REVISION NOTICE
Bell Helicopter **TEXTRON**
A Subsidiary of Textron Inc.

SUBJECT: **REVISION "A" TO ALERT SERVICE BULLETIN 407-04-66:
(FREEWHEEL AFT BEARING CAP 406-040-509-101, INSPECTION
AND REWORK OF)**

NO. 407-04-66

SUBJECT: Freewheel aft bearing cap 406-040-509-101, inspection and rework of

Figure 1. Location of the lubrication channel and the serial number

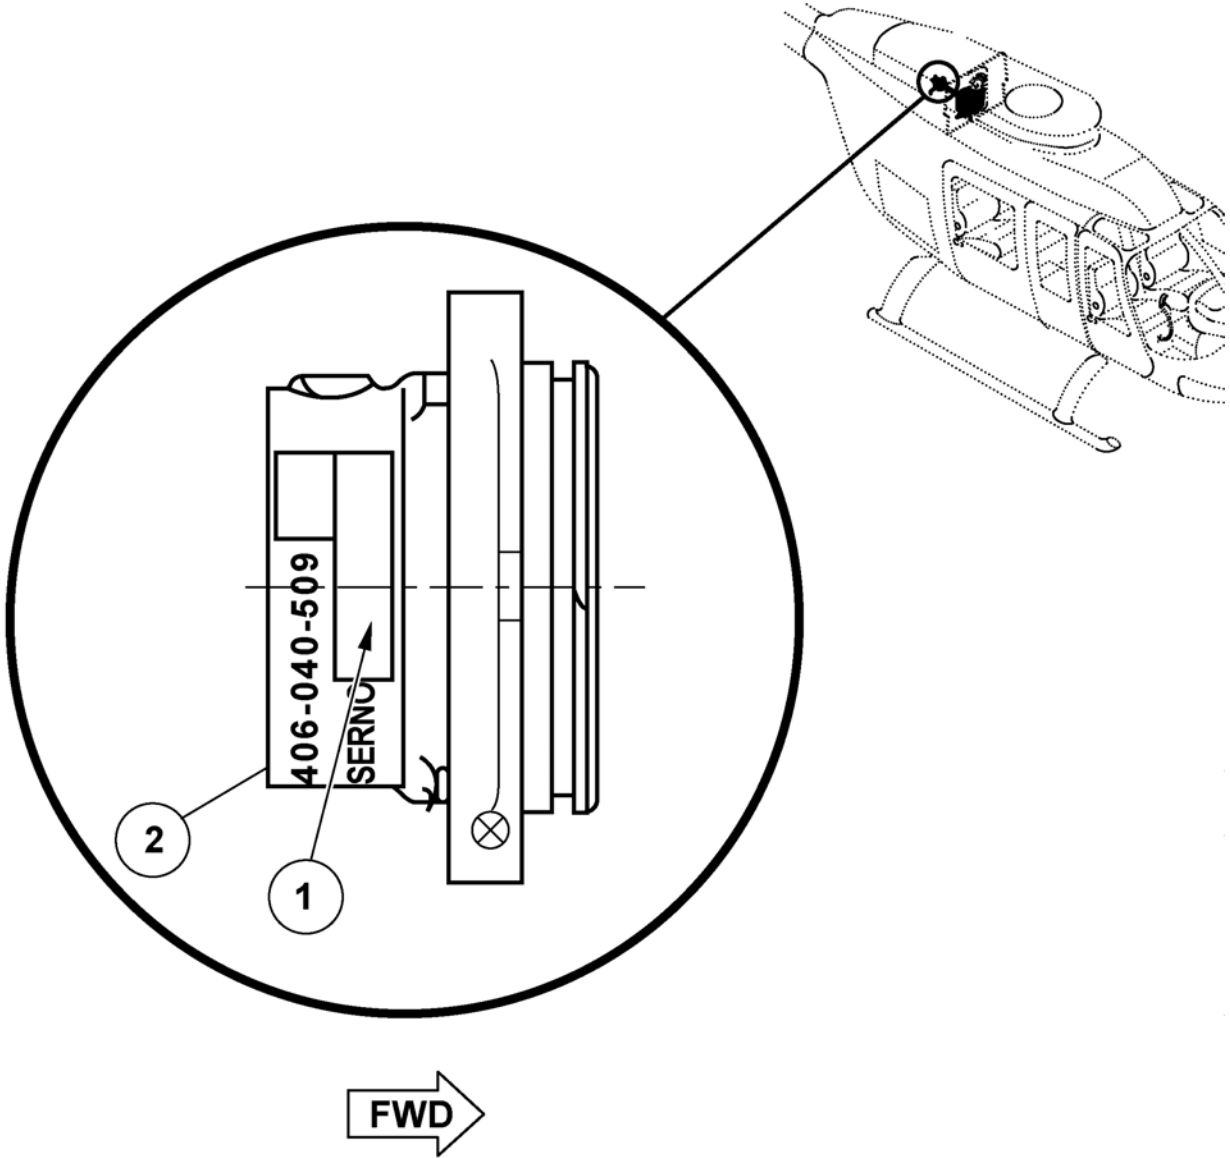
Bell Helicopter has found that some freewheel aft bearing caps are missing the lubrication channel intended to allow oil flow into the aft bearing support assembly. These caps may have been delivered on production aircraft or as spares.

1. Open the engine access doors.
2. Locate the serial number (1, Figure 1) of the freewheel aft bearing cap (2).
 - a. If the cap serial number is not listed in the HELICOPTER AFFECTED section, no further action is required. Close the access doors and continue with Step 3.
 - b. If the cap serial number is listed in HELICOPTER AFFECTED section, refer to the COMPLIANCE section and accomplish either PART II or III of this bulletin as directed. Contact Product Support Engineering Light Helicopters with the P/N, S/N, TSN, and TSO of the aft bearing cap and freewheel assembly.

Figure 2. Parts affected by the missing lubrication channel

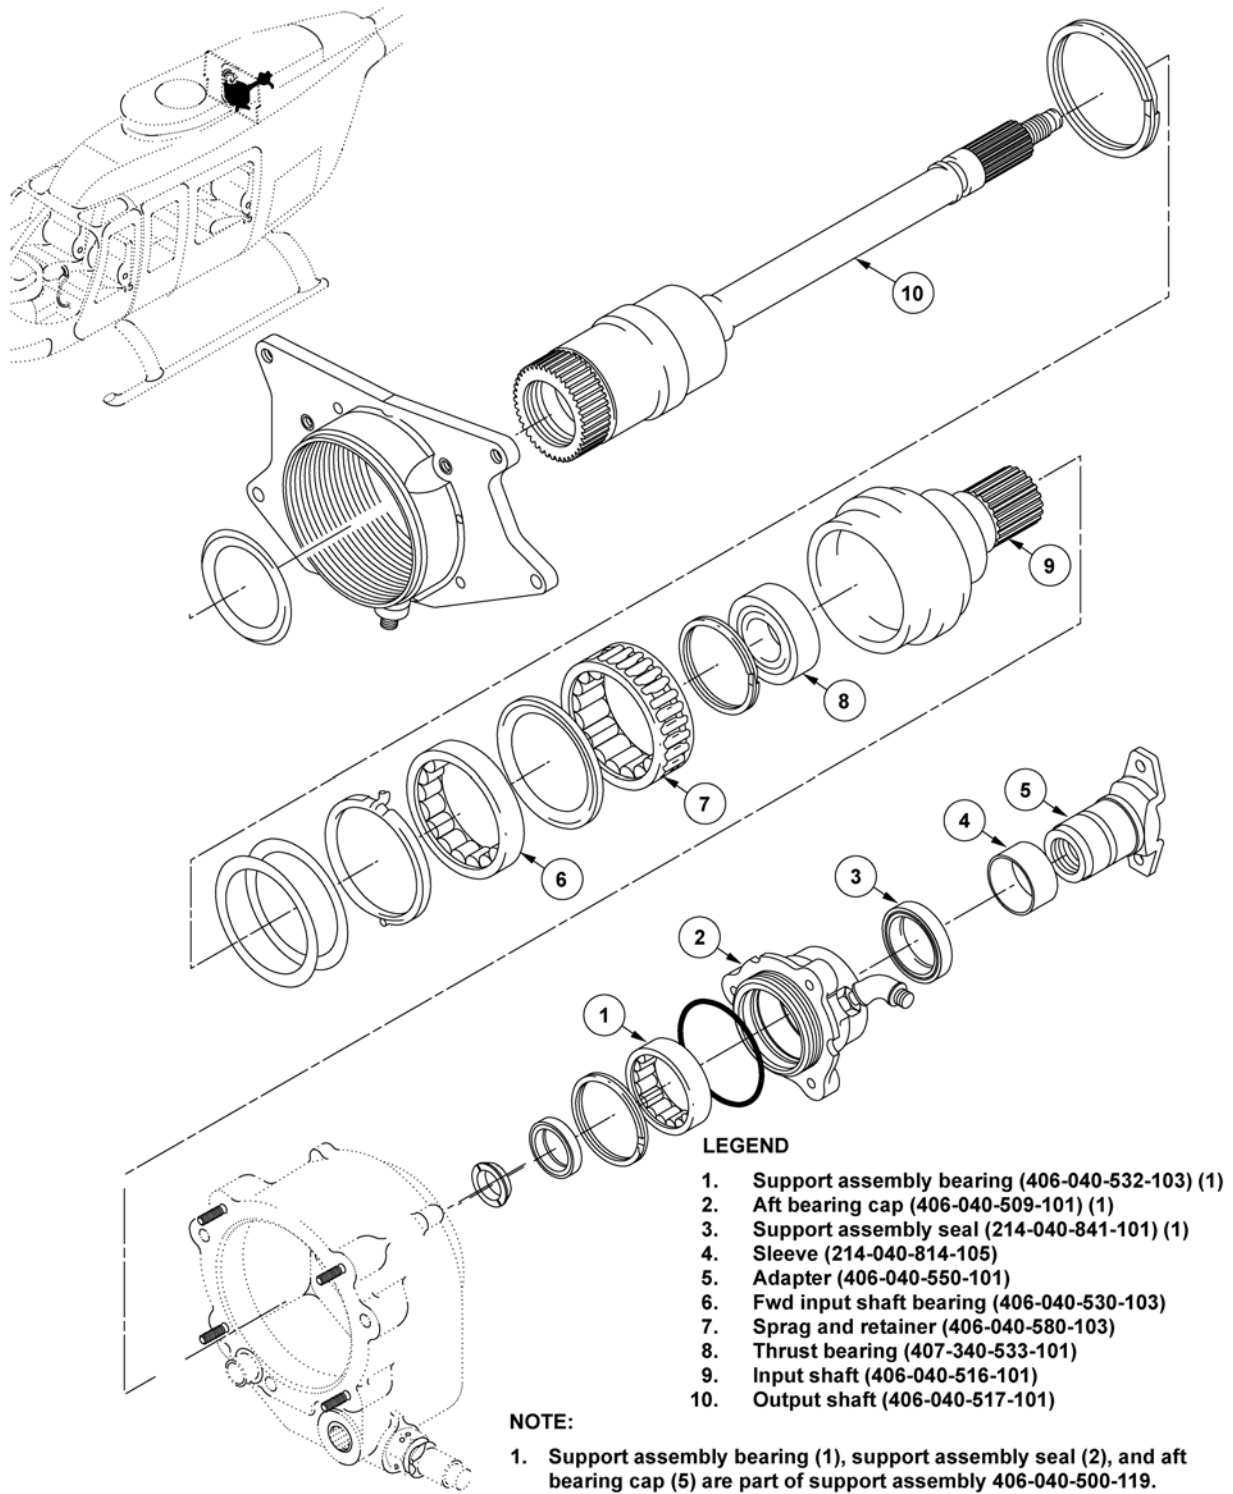
3. Remove the aft adapter (5, Figure 2) and aft bearing cap (2) (BHT-407-MM, Chapter 63).
4. Remove bearing (1) from the aft bearing cap (2) (BHT-407-MM, Chapter 63).

5. Remove and discard the support assembly seal (3).
6. Inspect support assembly bearing (1) for condition (BHT-407-CR&O). Replace bearing if defective .

2. Disassemble the freewheel assembly (BHT-407-CR&O, Chapter 63-30).
3. Discard the sprag and retainer (7, Figure 2), the output shaft (10), and the aft seal (2).
4. Visually inspect the remaining freewheel part details for condition (BHT-407-CR&O, Chapter 63-30).

2. Remove freewheel assembly (BHT-407-MM-6, Chapter 63).
 3. Disassemble the freewheel assembly (BHT-407-CR&O, Chapter 63-30).
 4. Discard the sprag and retainer (7, Figure 2) and the output shaft (10).

Revision "A" to this bulletin mandates the replacement of the output shaft 406-040-517-101 and sprag and retainer 406-040-580-103 for freewheel with discrepant aft bearing cap installed.

A PART IV of this bulletin mandates the replacement of the output shaft 406-040-517-101 and sprag and retainer 406-040-580-103 for freewheel with discrepant aft bearing cap installed.

Figure 3. Instructions required to modify the aft bearing cap 406-040-509-101

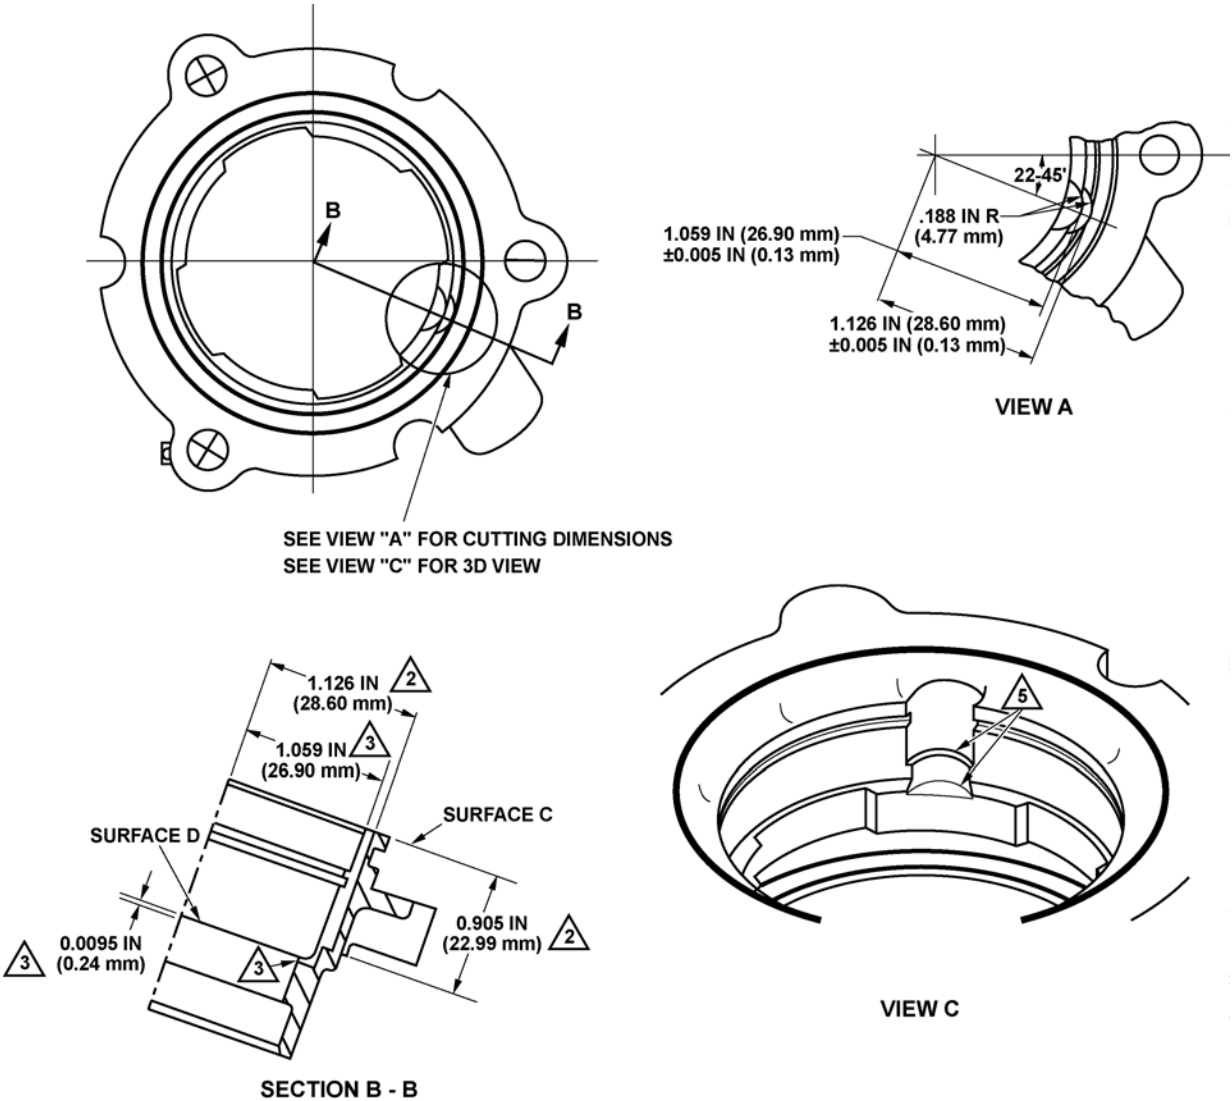
- b. Locally rework the aft bearing cap as shown in Figure 3. Use a vibrating stylus to identify locally-reworked cap assembly by adding letter "R" to the serial number on the cap.

- b. Locally rework the aft bearing cap as shown in Figure 3. Use a vibrating stylus to identify locally-reworked cap assembly by adding letter "R" to the serial number on the cap.

1. Surface finish to be 125 u inch RMS
2. Machine scallop 1.126 inch (28.60 mm) ±0.005 inch (0.13 mm) into bore. Length of scallop to be 0.905 inch (22.99 mm) ±0.010 inch (0.254 mm) from the surface C.
3. Machine scallop 1.059 inch (26.90 mm) ±0.005 inch (0.13 mm) into bore. Scallop to be 0.0095 inch (0.24 mm) ±0.0025 inch (0.06 mm) below surface D.
4. Break all sharp edges.
5. Machine scallop radius .020 inch maximum 2 places
